I-94 at 111th Street

Public Meeting #2
Public Meeting Detailed Summary

I-94 AT 111TH STREET INTERCHANGE Alternative 1: Tight Diamond, I-94 Under 111th Street

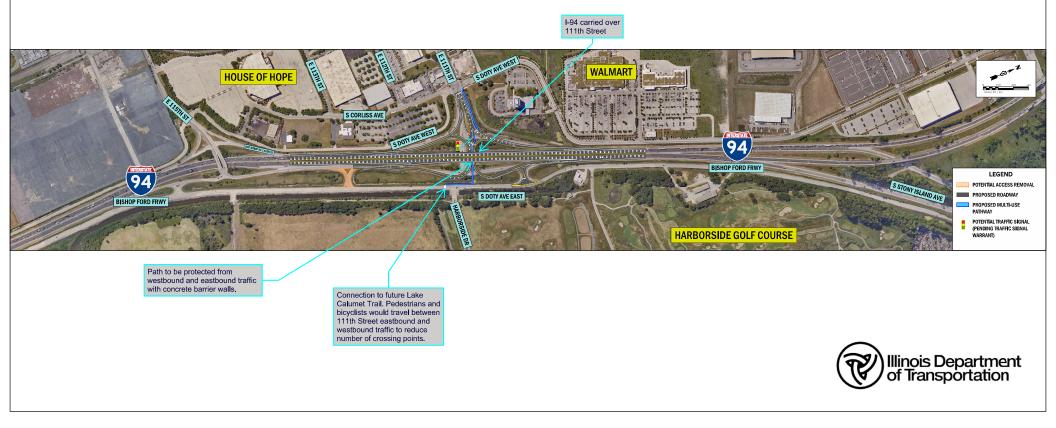
Number	Location of Note	Comment
1	Alternative 1	Multi motor
		The removal of the right in right access N of 111 should stay. They are used for local access across E Doty to W Doty. Cross access should not
		be removed
2	Alternative 1, pointing at east intersection of 111th St and WB I-94 ramps	Bridge?
	TITUI St and WB1 3 Tramps	Stop signs/traffic signal on Doty (unintellible)
3	Alternative 1, east side	No car access to Doty? (w/ removal of RIRO)
4	Alternative 2, east side	Do not remove RI/RO, Local access need to be able to cross without going so far N or south
5	Alternative 3, east side	Local access to E and W should remain. Do not remove RI/RO
6	Alternative 3, northeast corner	1 traffic signal controlling all? (Dangerous - electrical outages common)
7	Alternative 5, east side	Dangerous crossings for bikes + peds
